MECKLENBURG COUNTY
DEPARTMENT OF ENVIRONMENTAL HEALTH

APPLICATION FOR SOIL INVESTIGATION

APPENDIX B
SITE EVALUATION

SITE INVESTIGATION REPORT
INDIVIDUAL SEPTIC TANK SYSTEM
WITH SUBSURFACE,
SOIL ABSORPTION,
EFFLUENT DISCHARGE

* See Diagram on Back (Include Soil areas property lines roads streams gullies rock areas fill areas, wells, water bodies, slope patterns etc

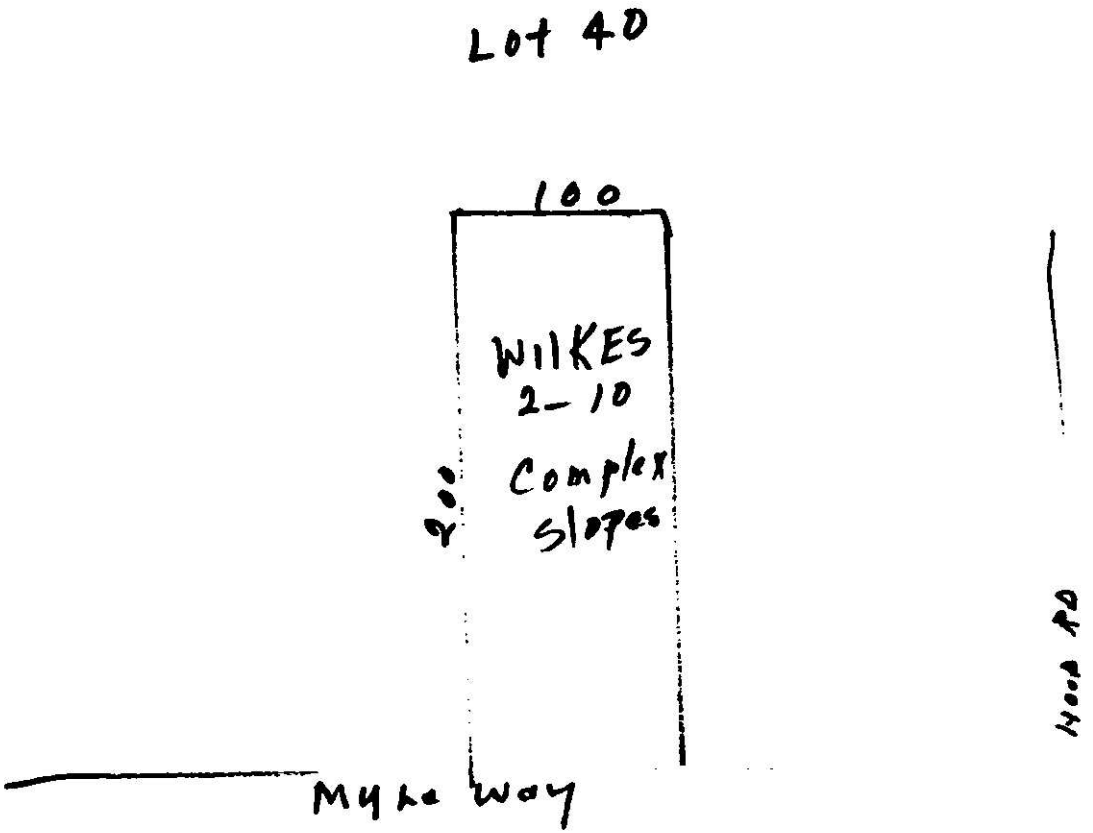
FACTORS		AREA 1	AREA 2	AREA 3	AREA 4
1. SLOPE (%)	S		S	S	S
	PS	2-10	PS	PS	PS
	U		U	U	U
2. SOIL TEXTURE (12-36 in.) (Sandy loamy clayey, Note 2.1 Clay)	S		S	S	S
	PS	2-1 clay	PS	PS	PS
	U	Saprolite	U	U	U
3. SOIL STRUCTURE (12-36 in.) (Clayey Soils)	S		S	S	S
	PS	MASSIVE	PS	PS	PS
	U		U	U	U
4. SOIL DEPTH (In.)	S		S	S	S
	PS	48	PS	PS	PS
	U		U	U	U
5. RESTRICTIVE HORIZONS (In.) (Impervious Strata Rock)	S		S	S	S
	PS	Saprolite	PS	PS	PS
	U		U	U	U
6. SOIL WETNESS/WATER TABLE (External Internal)	S		S	S	S
	PS	SLOW	PS	PS	PS
	U		U	U	U
7. SOIL PERMEABILITY (Percolation Rate)	S		S	S	S
	PS	SLOW	PS	PS	PS
	U		U	U	U
8. OTHER (Specify)	S		S	S	S
	PS		PS	PS	PS
	U		U	U	U
9. SITE CLASSIFICATION		Unsuitable

SOIL SERIES: Wilkes

Lot 40
100
WILKES
2-10
Complex
Slopes
200'
Myra Way
Wood Rd
